Re: Final Plat S/D 88-4 - AUTUMN RIDGE 2ND ADDITION

STAFF REPORT
(Final Plat; Preliminary Approved 2/11/88)

CASE NUMBER: S/D 88-4 - AUTUMN RIDGE 2ND ADDITION

AUTUMN RIDGE 2ND ADDITION
TO WICHITA, SEDGWICK COUNTY, KANSAS

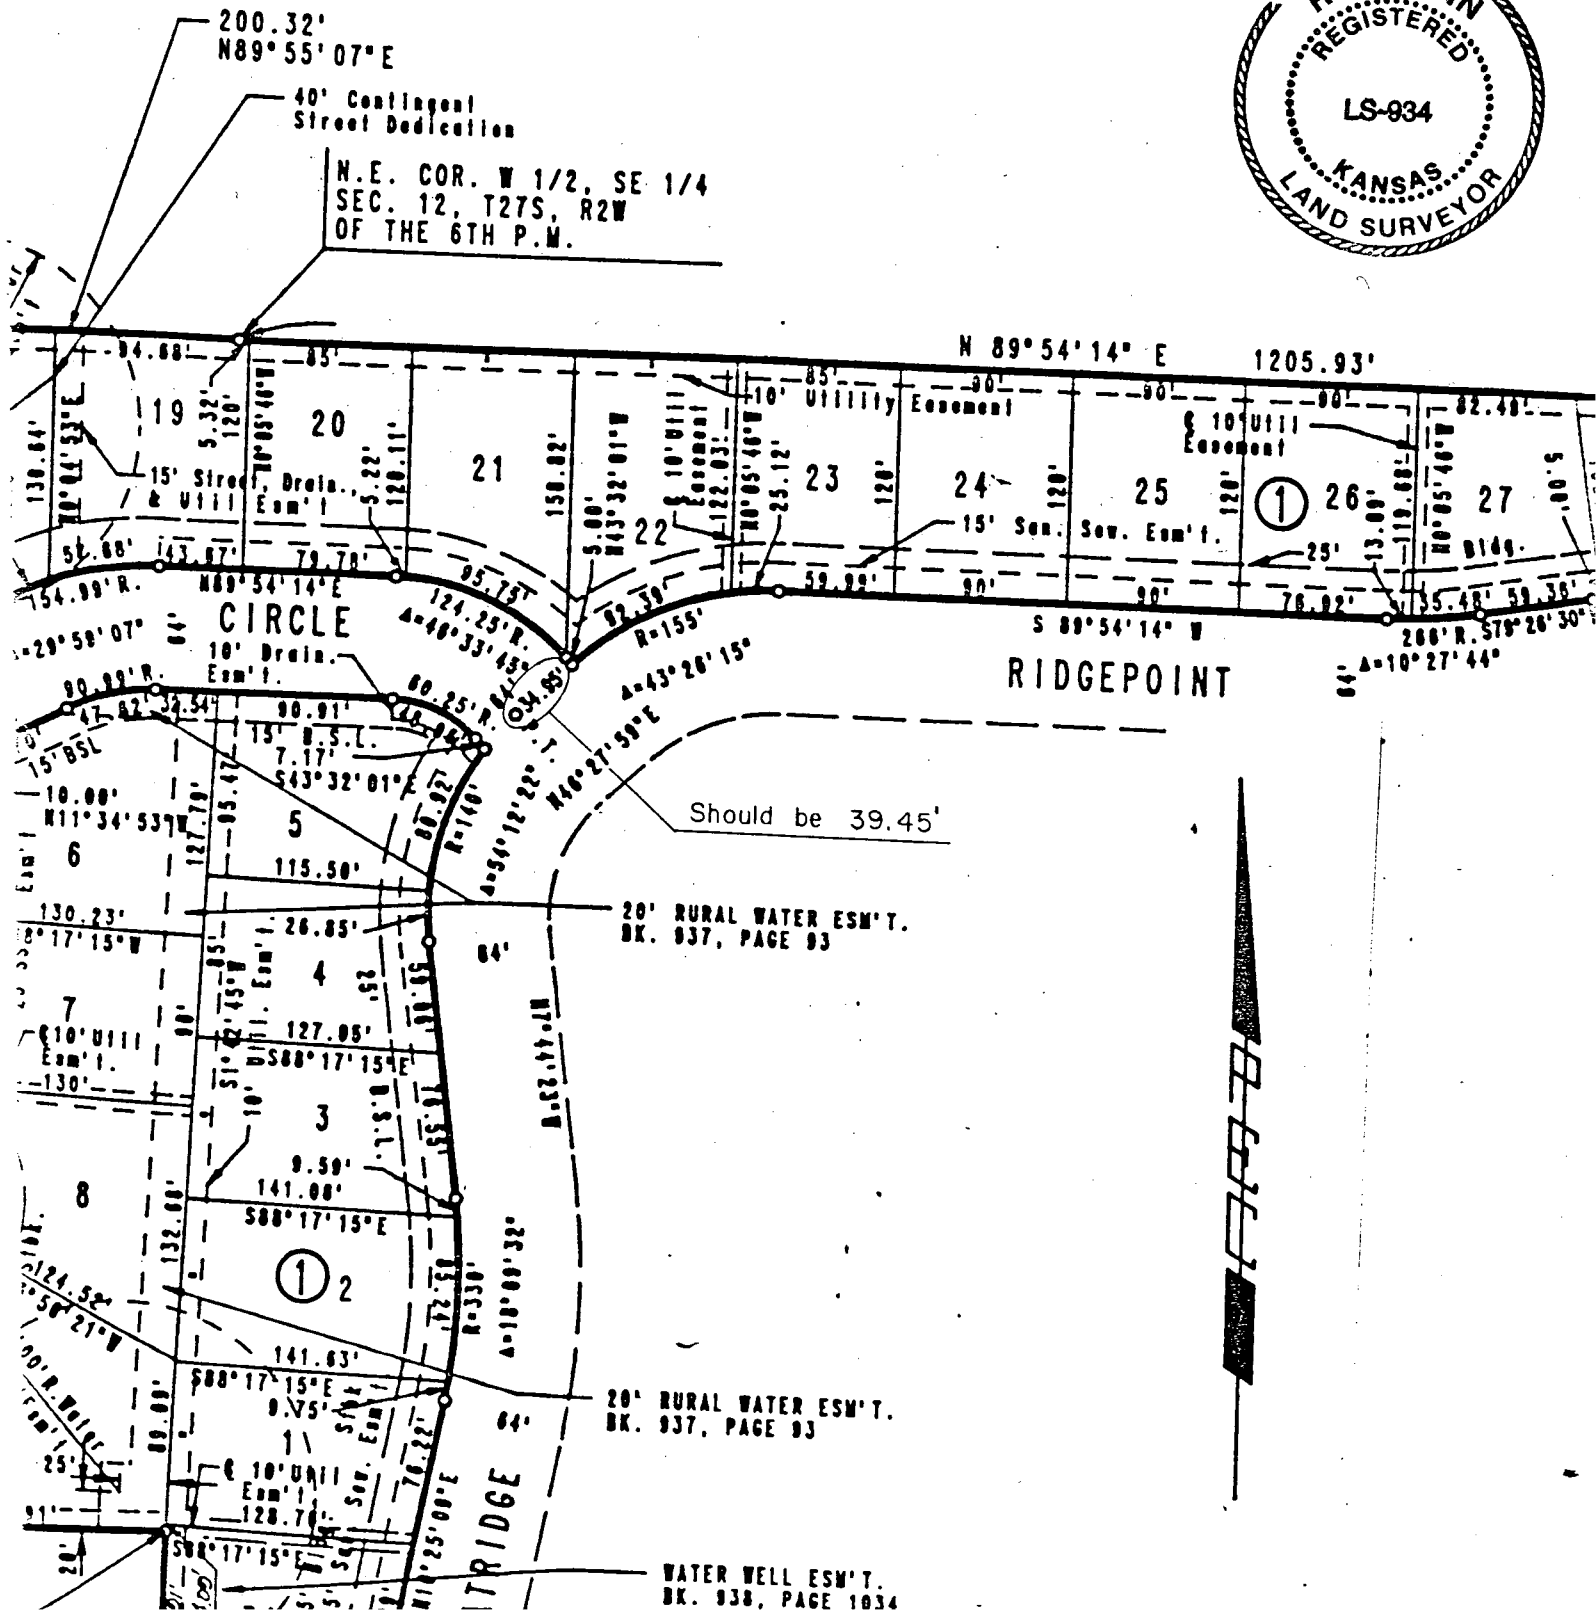
We, Professional Engineering Consultants, P.A., Engineers in aforesaid County and State do hereby certify that a certain description error exists on the plat drawing at Ridgepoint Circle showing dimension between a p.t. and the property line.

I have examined the final plat of Autumn Ridge 2nd Addition to Wichita, Sedgwick County, Kansas, and have found that a certain error exists on the plat drawing at Ridgepoint Circle showing a dimension between a p.t. and the property line; said dimension should be corrected to show the correct distance as provided in the attached drawing.

The accompanying drawing is a true and correct exhibit of the correction as noted.
